CONSULTATION RESPONSE TO PLANNING OR RELATED APPLICATION

Comments provided by	Officer Name and Post: Mark Douglas Lead Officer (Built Heritage & Design)	Contact e-mail/number: mtdouglas@scotborder.gov.uk 01835 826563
Planning Application Reference	18/00137/FUL	
Proposed Development	New house	
Site Location	Land NE The Rest, Murrayfield, St Abbs	
Date	09/04/2018	
Background	<p>The application site lies within the St Abbs conservation area.</p> <p>The focus of the conservation area is the harbour but the area extends to the small headland beyond Castle Rock house. The development pattern close to the proposed site is generally characterised by terraces of “fishing” cottages on Murrayfield and this pattern has generally been picked up by more recent development with the housing with houses generally being parallel to the street in a grid a grid pattern, both Southlea and the original part of the The Rest faced SE at right angles to the streets. Castle Rock is an exception to this and stands alone.</p> <p>I also note that the conservation area boundary only takes in part of the grounds of The Rest.</p> <p>A Design Statement has been submitted in support of the application</p> <p>I apo

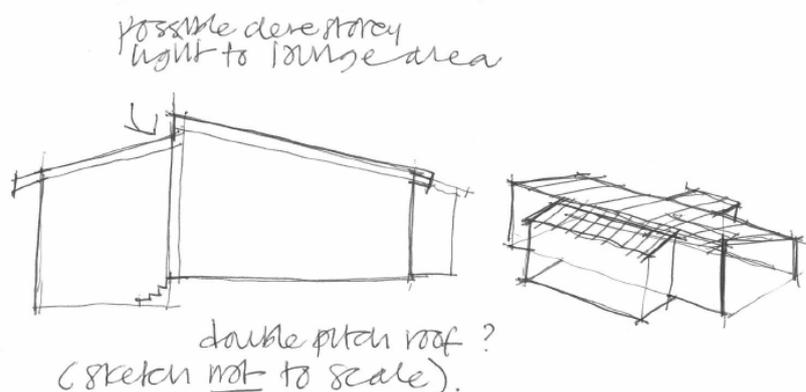
The new house is not "anchored" in the site in terms of its relationship with the adjacent buildings, which as described above are generally laid out with building lines parallel to the roads. The Design Statement does not explore other locations within the land owned by the applicant. I appreciate that the view would not be as good but Option A illustrated below would fit better into the grain of the conservation area.

If option A is ruled out, then potentially option B is a better solution which at least has a better relationship with adjacent buildings and still has a good outlook.
